This application has been prepared by Ethos Urban (formerly JBA) on behalf of the University of New South Wales (UNSW), pursuant to Section 96(1A) of the *Environmental Planning and Assessment Act, 1979* (EP&A Act) to modify Development Consent SSD 7518 relating to the Science and Engineering Building at the UNSW Kensington Campus (the site).

The modification relates to the inclusion of a new mezzanine floor above the goods store area at ground level, in addition to the extension of a lift core through the podium slab of the double height basement / lower ground level which contains the IO Myers Theatre and Studio 1.

2.0 Proposed Modifications to the Consent

Figure 1- Proposed extension of the lift core through the podium slab (east elevation)

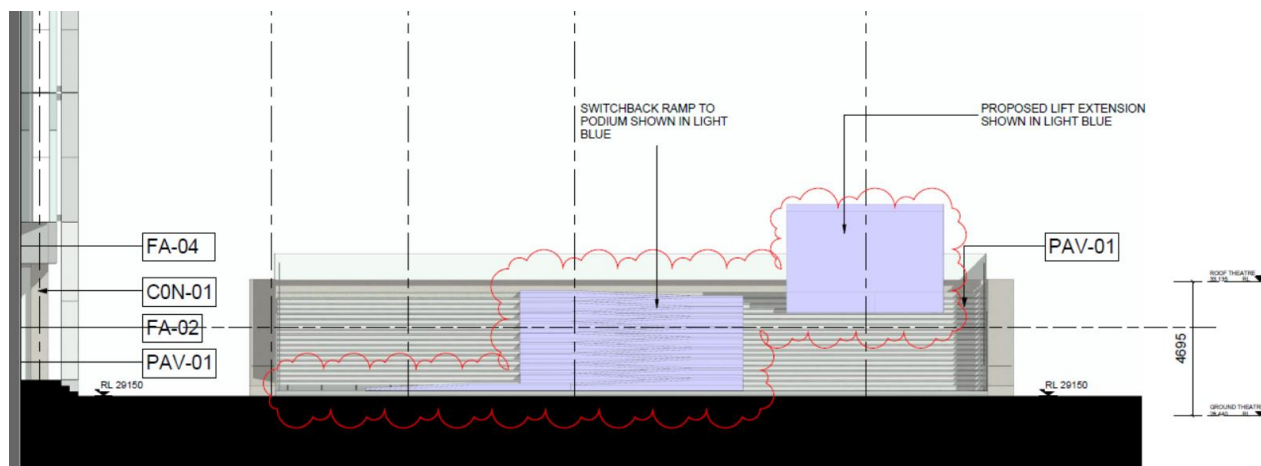
Extension of a lift core through the podium slab

It is proposed to extend the approved lift core in the north of the lower ground / basement level (located between the IO Myers Theatre and Studio 1) through the podium slab. This lift services the IO Myers Theatre, Studio 1 and the foyer. The extended lift core will protrude to RL35.1, which is 1.96m above the current maximum height of the terraced podium (refer to **Figure 1**).

The podium provides an inviting outdoor space for a variety of flexible uses. The lift extension will enable an alternate means of access to the podium roof which is raised approximately 4.7m above ground level.
